The Junction

Heritage Conservation District

It is my pleasure to write on behalf of the Junction Heritage Conservation District (HCD) Committee regarding the zoning application # 14 152731 WET 13 OZ for 2978-2982 Dundas Street West & 406-408 Pacific Avenue.

BEFORE: *Junctioneer* photo of the Handyman Shop at 3077 Dundas Street West, 22 October 2009.

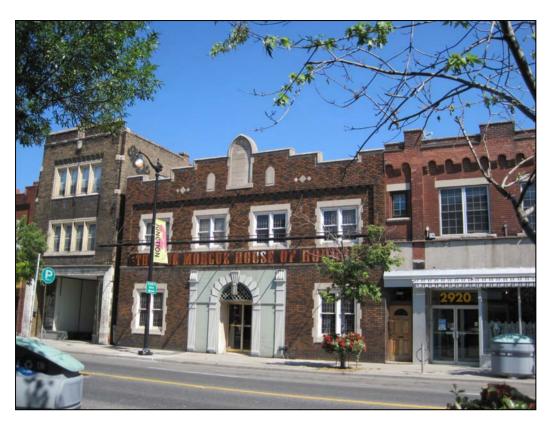
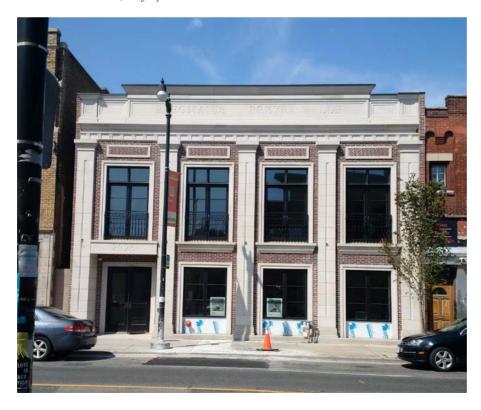
The Starbucks building that replaced the Handyman Shop at 3077 Dundas Street West.⁴ The Starbucks design aligns with the character of the adjacent buildings and follows the various Performance Standards outlined in #19, which includes complimentary building materials, cornice lines and step-backs for adding additional height, etc. While the height of the new building also exceeds the adjacent property, it does not overwhelm the visual impact of the streetscape, as will happen at the subject site.
